Updated layout

We have made changes to the proposed layout of Kirknewton Solar and BESS Farm based on the feedback received at the first public exhibition and the results of environmental surveys.

NEW SITE LAYOUT

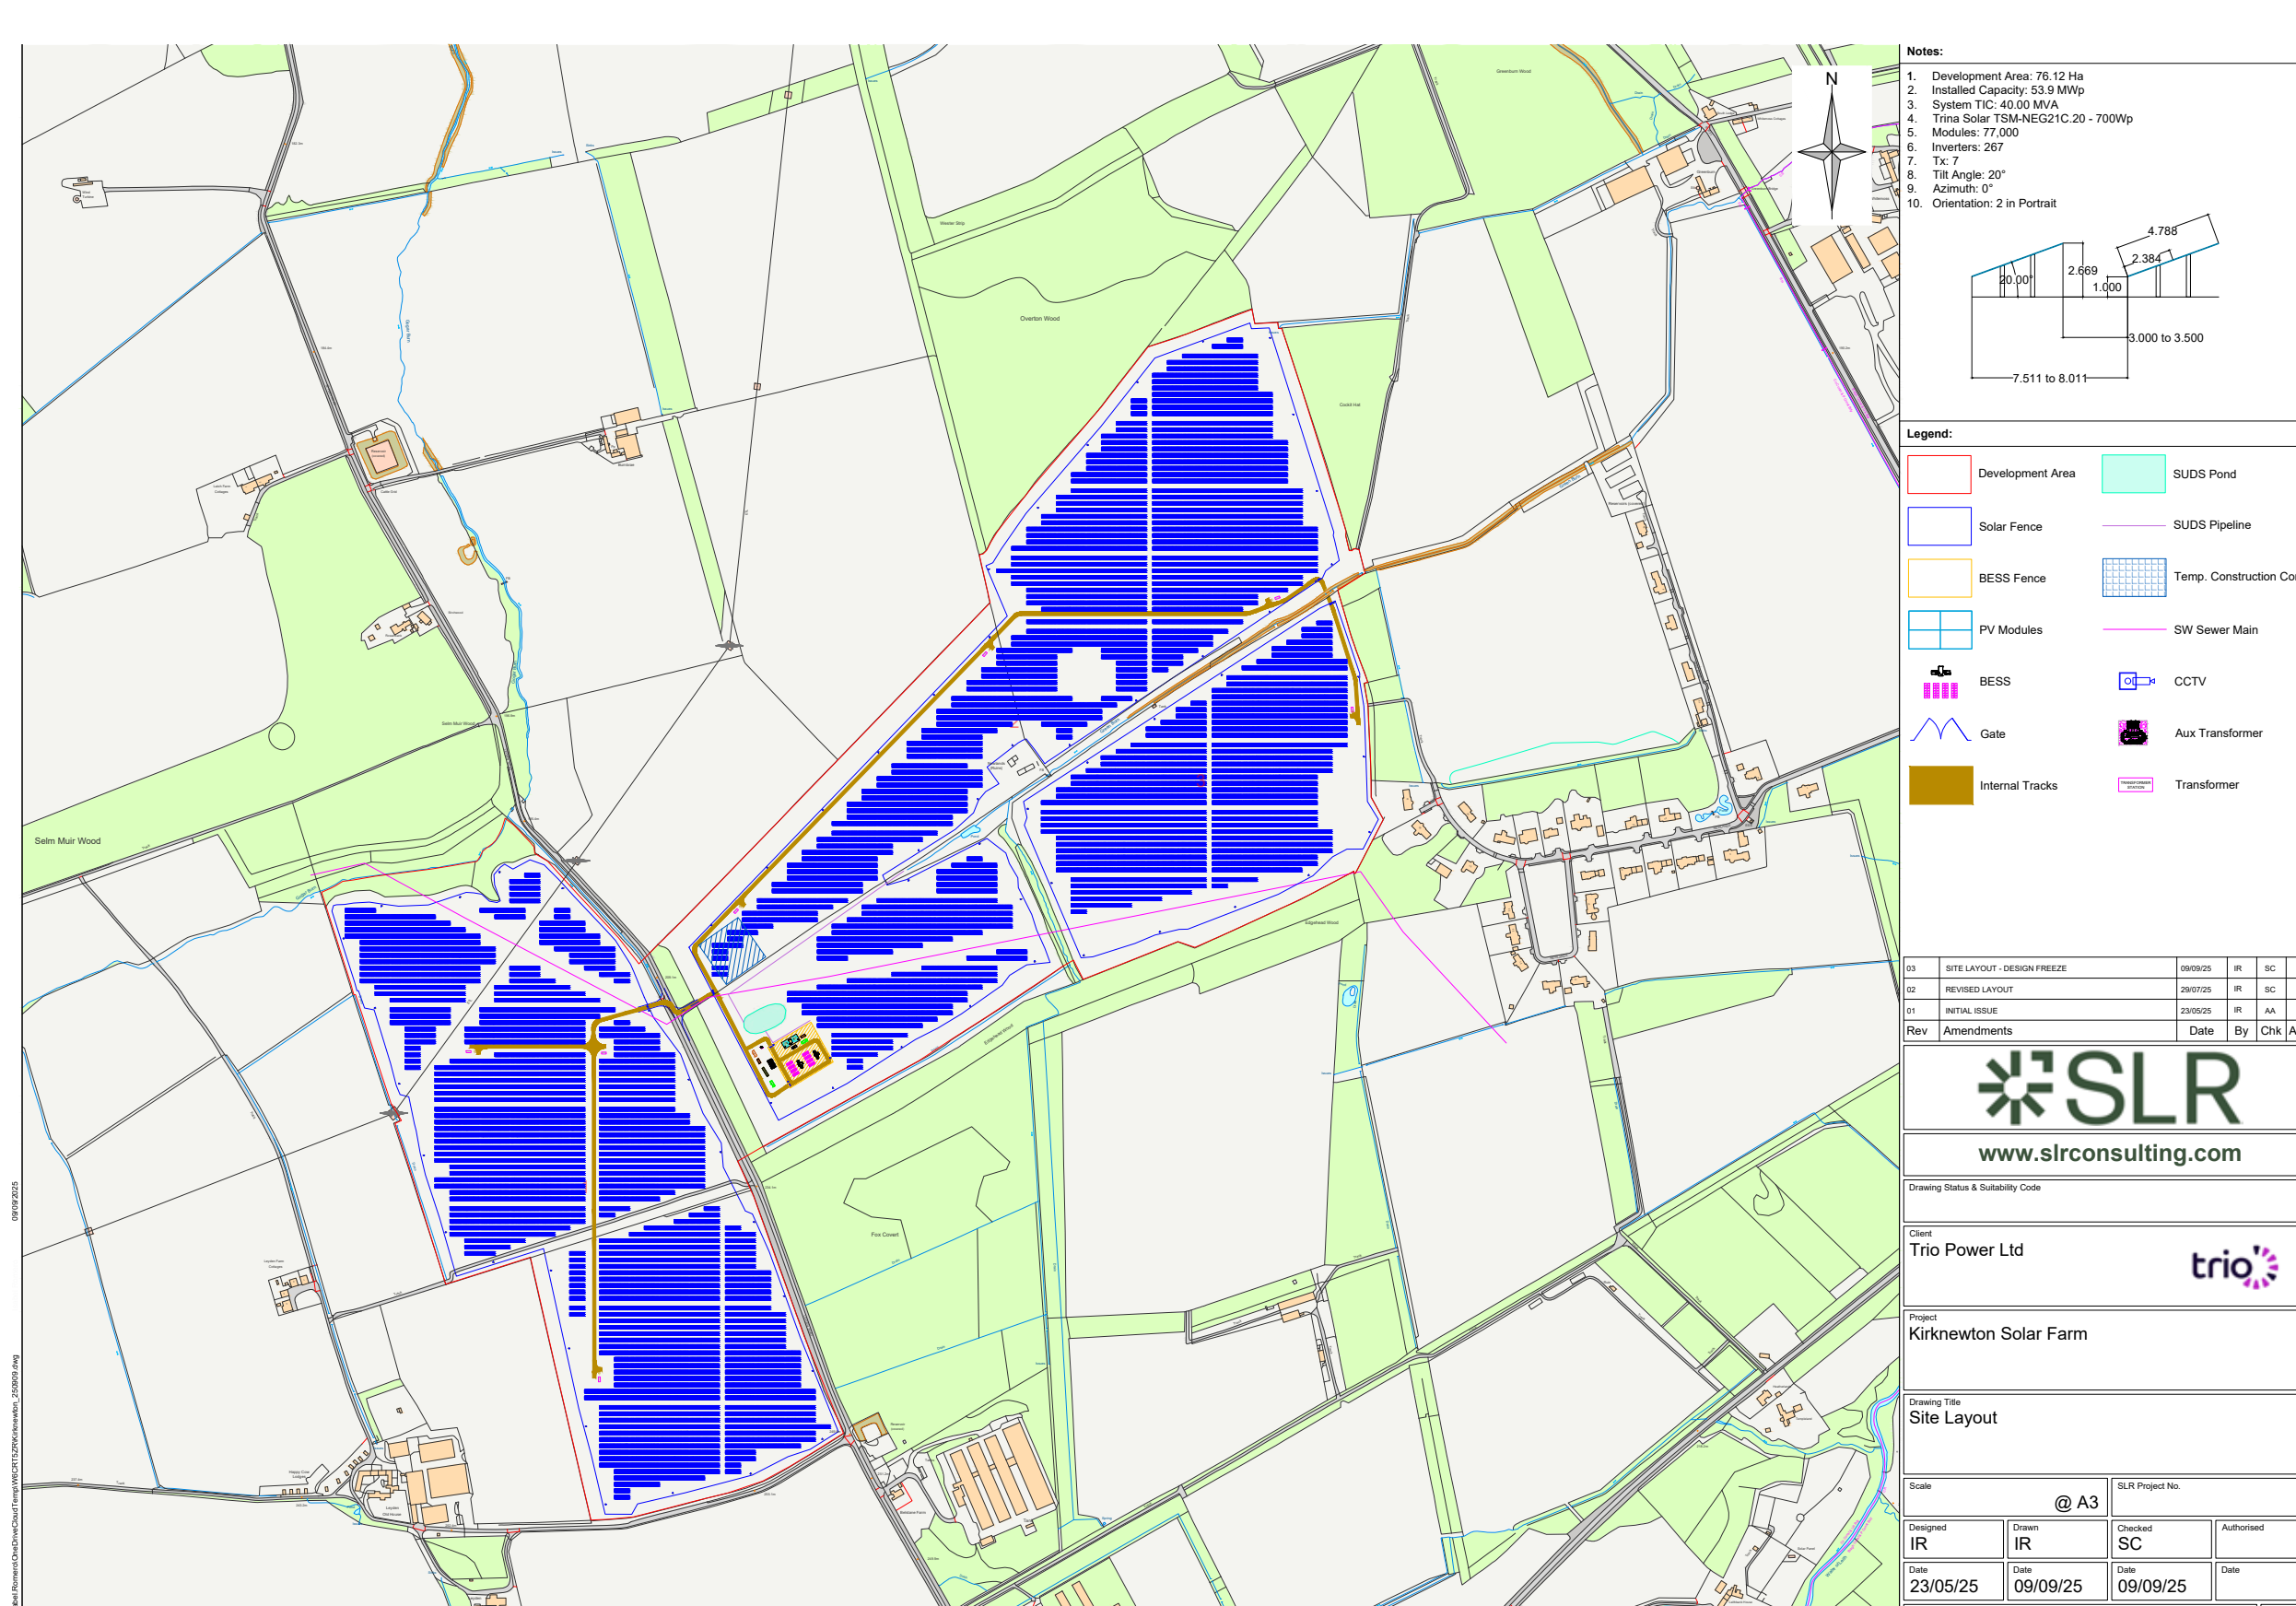
- Moved the BESS further north, slightly downhill, to create a 50m buffer from the watercourse on the site's southern edge
- Increased the buffer between the solar panels and the houses at Newlands to allow space for additional planting to reduce views of the project from those houses.
- Included new hedgerows and tree planting to reduce views from the north and west.
- Included an easement of 10m along the water main that crosses the site to comply with Scottish Water guidance.
- Adjusted the fence line in the eastern land parcel to ensure that walking access around the field perimeters remains open.
